May 21, 2018
IDEA PUBLIC SCHOOLS – IDEA Brownsville Robindale Phase I

ADDENDUM NO. 1

A. PURPOSE AND INTENT
This addendum is issued for the purpose of modifying the plans and specifications for the IDEA PUBLIC SCHOOLS – IDEA Brownsville Robindale Phase I

Date:	May 10, 2018
Scale:	As Noted
Project Architect:	David Monreal, AIA
Drawn By:	ETHOS
Job No:	IDEA Robindale Phase I
Sheet:	P3.02

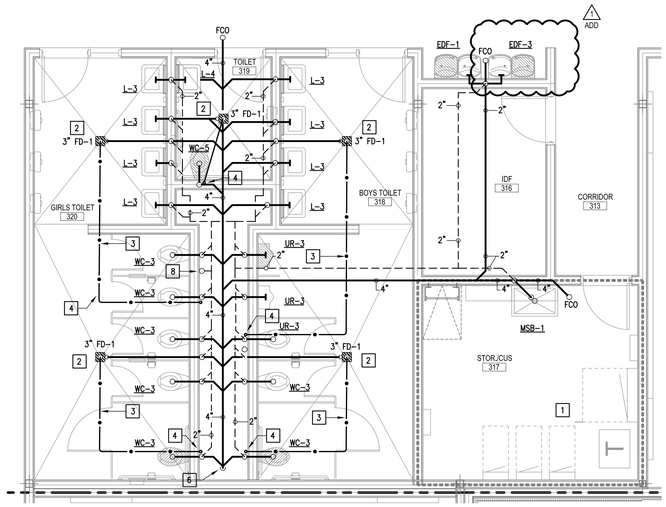
19) Sheet P3.02:
    a) Revised drinking fountain designation at Corridor. See attached sheet.

Date:	May 10, 2018
Scale:	As Noted
Project Architect:	David Monreal, AIA
Drawn By:	ETHOS
Job No.	IDEA Robindale Phase I
Sheet:	P4.01

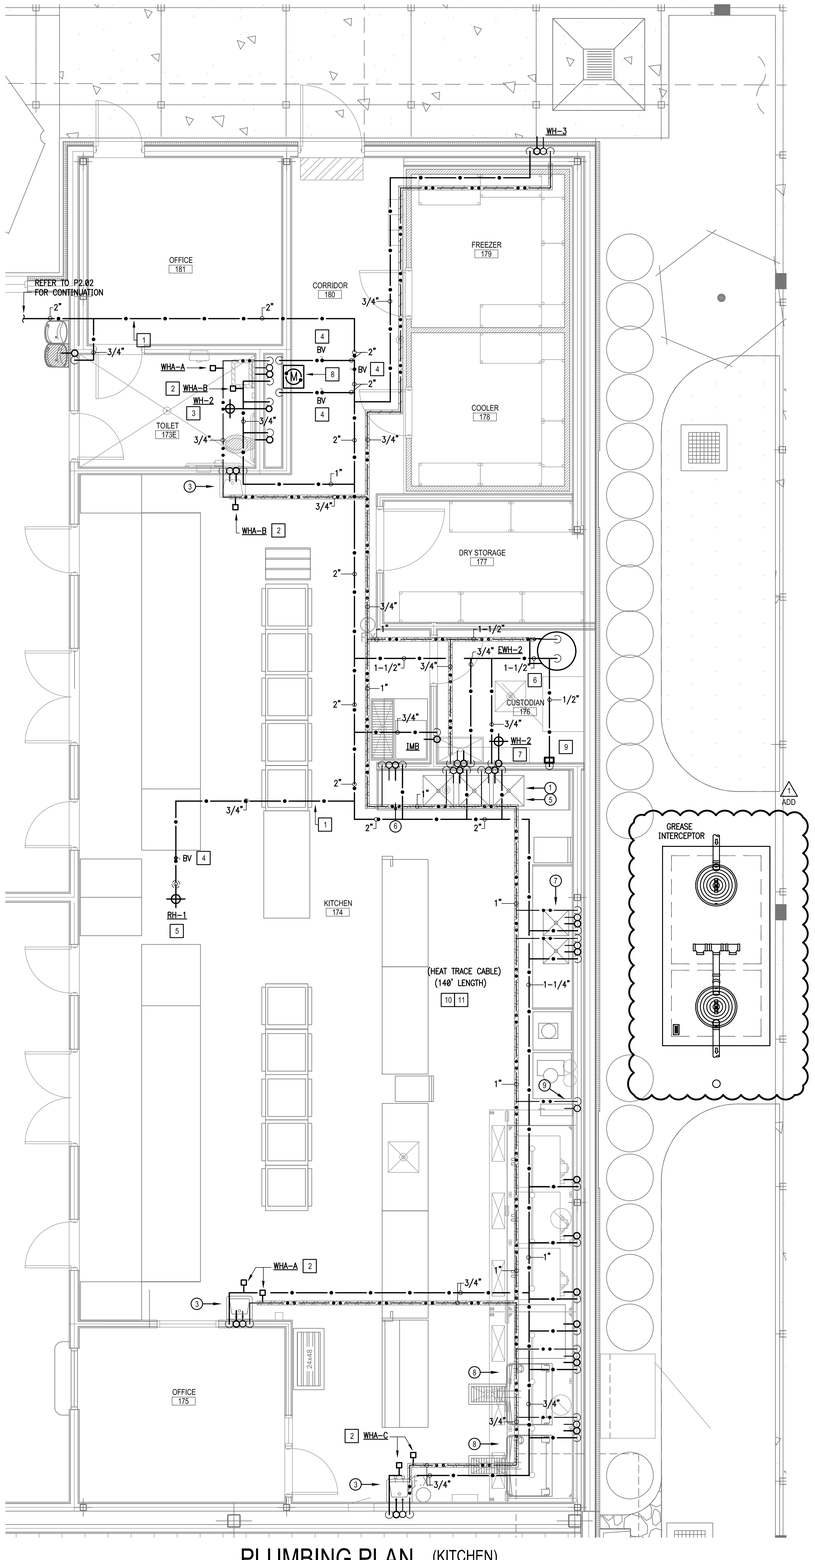
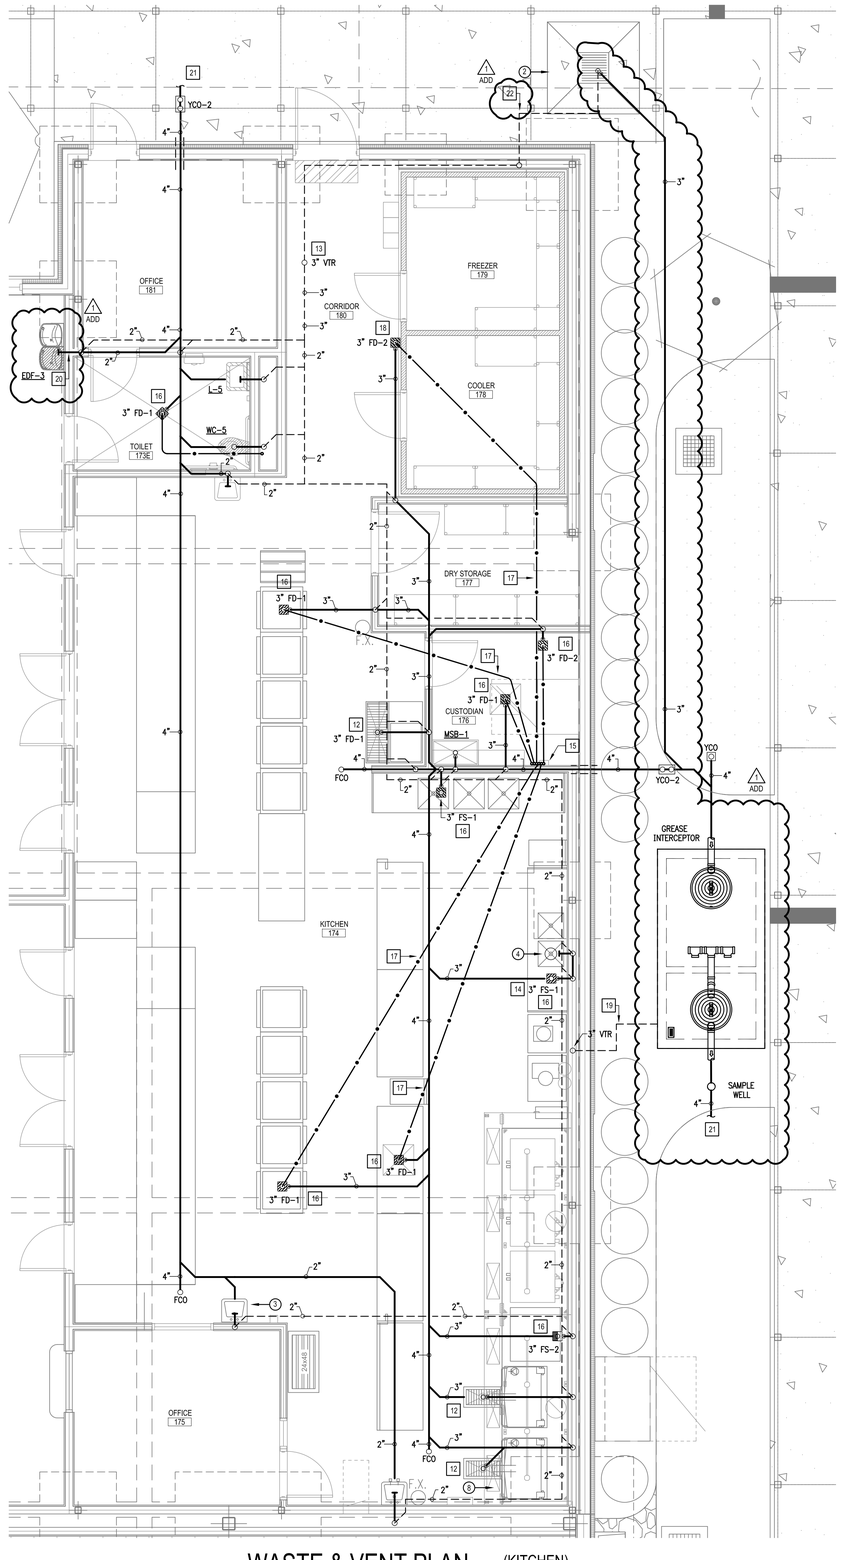
20) Sheet P4.01:
    a) Revised drinking fountain designation at Cafeteria. See attached sheet.
    b) Revised Grease Trap location. See attached sheet.
    c) Revised sewer routing serving catch basin. See attached sheet.
    d) Revised plumbing keynotes. See attached sheet.

Date: May 10, 2018
Scale: As Noted
Project Architect: David Monreal, AIA
Drawn By: ETHOS
Job No. IDEA Robindale Phase I
Sheet: P6.03

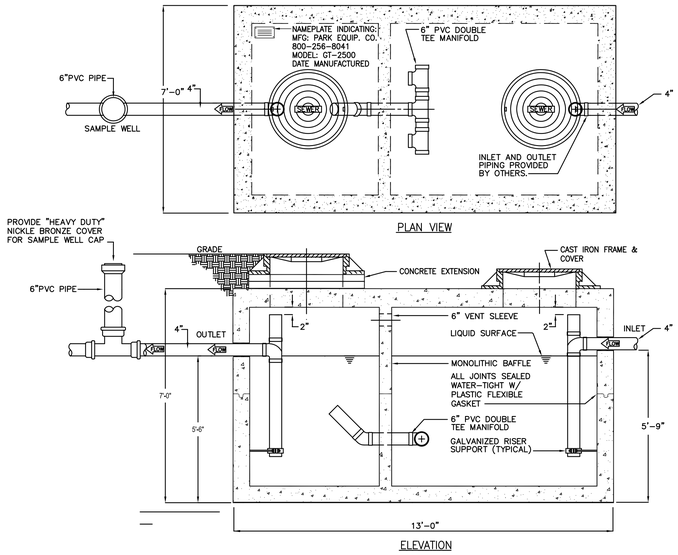
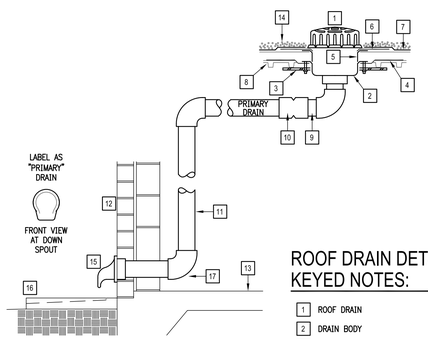
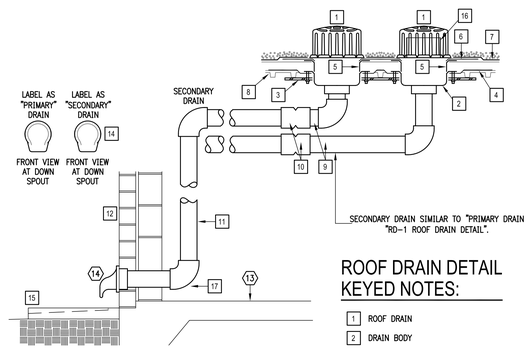
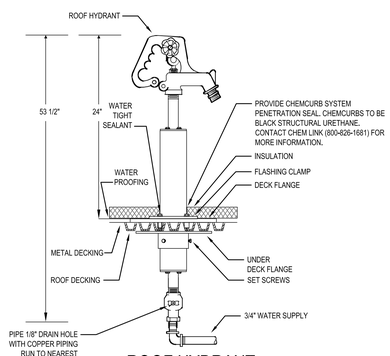
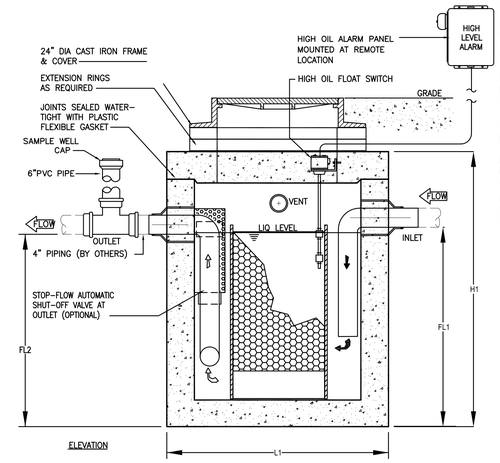
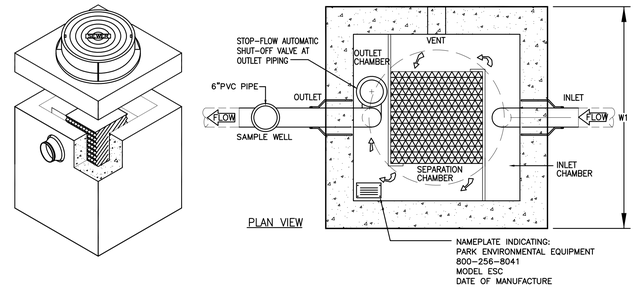
23) Sheet P6.03:
    a) Revised plumbing details. See attached sheet.

Date:	May 10, 2018
Scale:	As Noted
Project Architect:	David Monreal, AIA
Drawn By:	ETHOS
Job No.	IDEA Robindale Phase I
Sheet:	P5.01

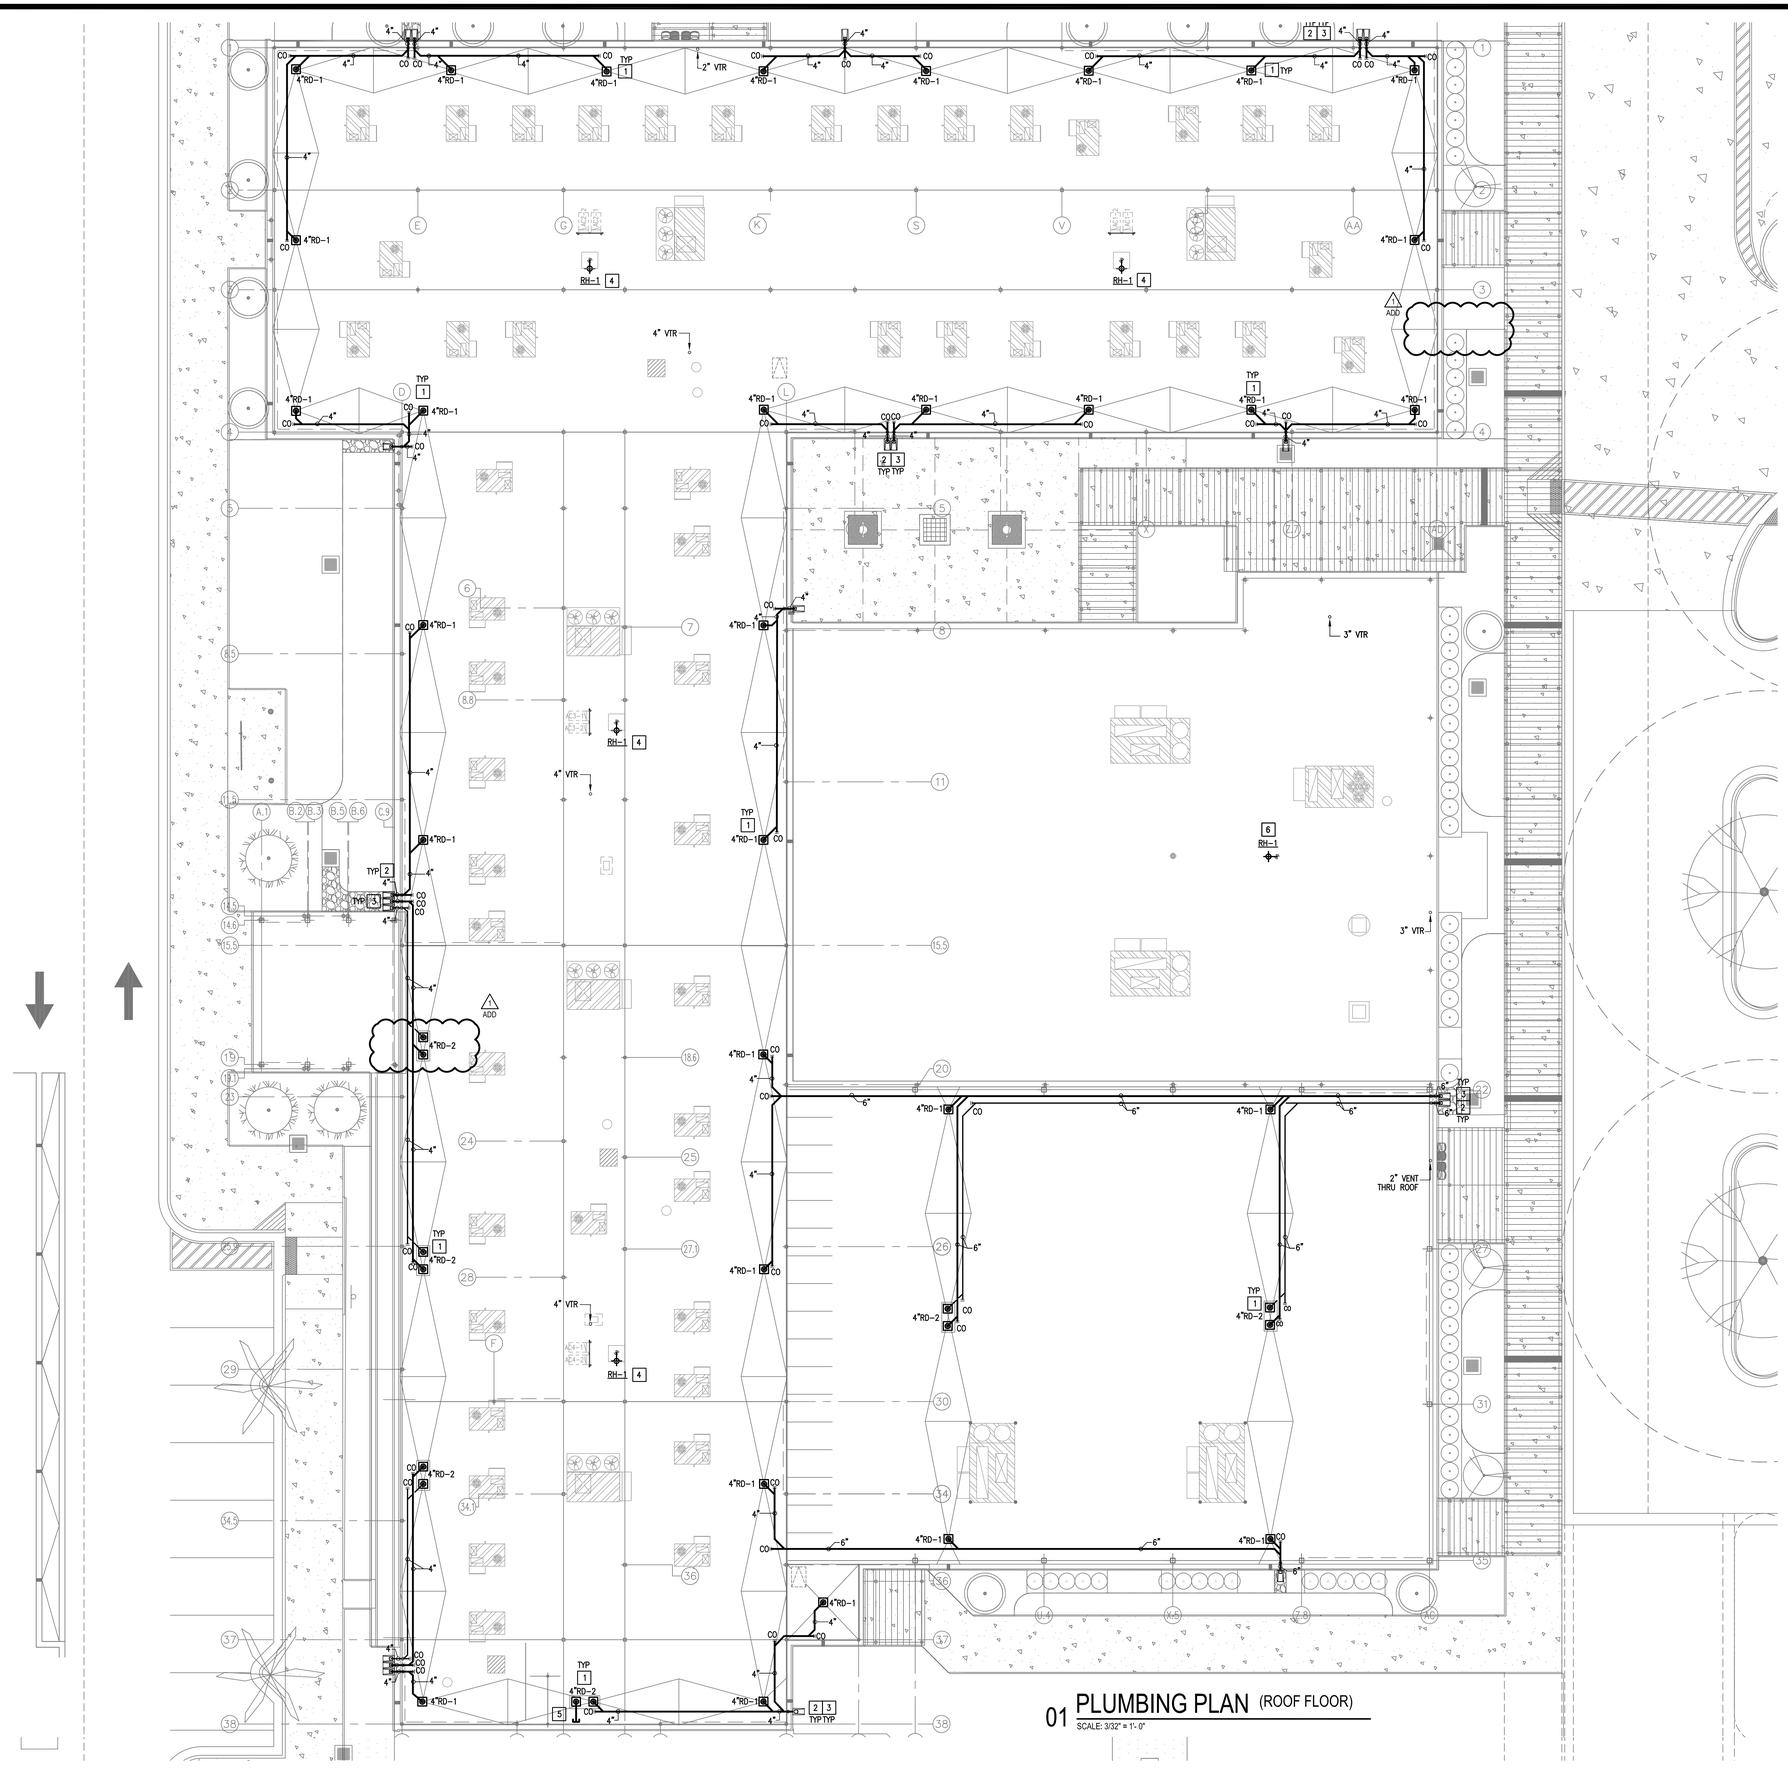
21) Sheet P5.01:
    a) Revised roof plan. See attached sheet.
